PCN Title Affected Products	Mako G surface treatment change to black powder coating Mako G camera family		
PCN Number	PCR-2017-03-05	PCN Issue date	2017-July-20 Updated Dec. 04
Contact	Inside Sales Team		
Change Type			
<ul> <li>Regulatory / Compliance</li> <li>Mechanical Specification</li> <li>Electrical Specification</li> <li>Optical Specification</li> </ul>	<ul> <li>Firmware Specification</li> <li>Accessories Specification</li> <li>Discontinued</li> <li>Component Change</li> </ul>

## Figure 2 – Front flange and back plate vs. bottom plate: housings with legacy silver nickel plating vs. new black powder coating

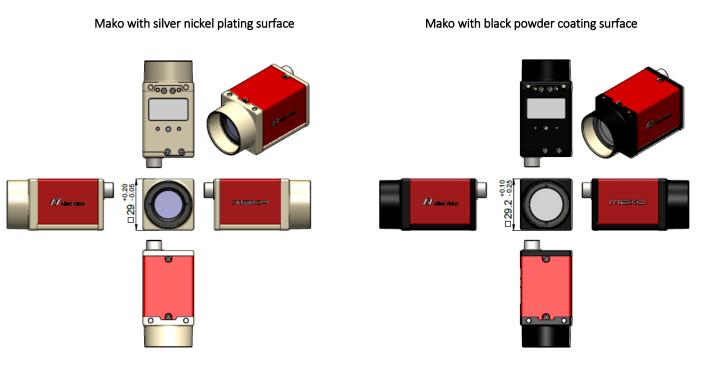
The Mako housing (back plate, bottom plate, and front flange) surface treatment will be changed from nickel plating to black powder coating. The change is cosmetic and will not have a negative effect on the image quality or camera performance. There are a slight dimension increases (<0.2 mm), see Figure 1 and Figure 2 below for a detailed comparison of the legacy and new finishes.
